## NOTICE OF NON-PERFORMANCE

On December 17, 2025, Energy Safety conducted an inspection of PG&E's WMP initiatives in the vicinity of the city of Greenbrae, California. The inspection report is enclosed herewith. Energy Safety found the following deficiencies:

# INSPECTION REPORT

Deficiency 1

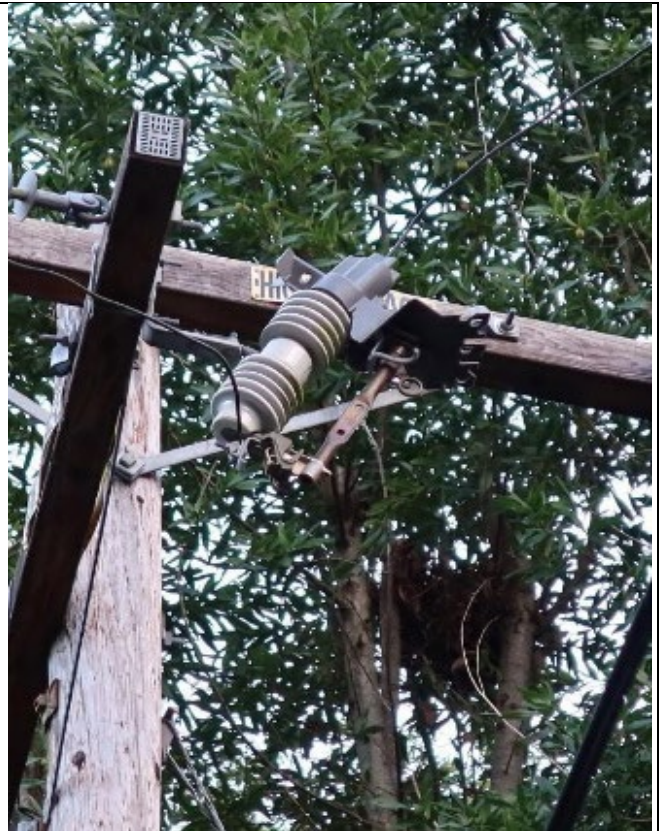
In the 2025 Q2 Quarterly Data Report submission, PG&E reported that work on WMP initiative 8.1.2.10.5 - Non-Exempt Expulsion Fuses was completed at Pole ID 120165952, Grid Hardening ID 31700387 at 309 Evergreen Dr, Greenbrae, CA, 94904, USA, 37.9416516298664, -122.560765100057. At this location the inspector observed that Solid Blade disconnects were installed without a 10-foot firebreak clearance. The inspector's observation is documented in Deficiency 1 photographs, which are attachments to this report. Photo numbers IA1Img1, IA1Img2, IA1Img3, and IA1Img4, depict Solid Blade disconnects without a 10-foot firebreak clearance.

1. Exempt fuses were not installed at the subject pole.
2. The inspector observed Solid Blade disconnects on the subject pole.
3. The inspector did not observe a 10-foot firebreak clearance around the subject pole.
4. No reclosers, sectionalizers, or voltage regulators were observed at the subject pole.

**IA1Img1:** Pole not cleared.

**IA1Img2:** Solid blade disconnect one.

**IA1Img3:** Solid blade disconnect two.

Deficiency 1. Energy Safety observed that in implementing 2025 WMP initiative 8.1.2.10.5 - Non-Exempt Expulsion Fuses, PG&E failed to complete the installation of Non-Exempt Expulsion fuses on Pole ID 120165952, Grid Hardening ID 31700387 at coordinates 37.9416516298664, -122.560765100057. Energy Safety considers this non-performance to be in the Minor risk category. PG&E must complete a corrective action for this deficiency by 12 months from date of this notice.
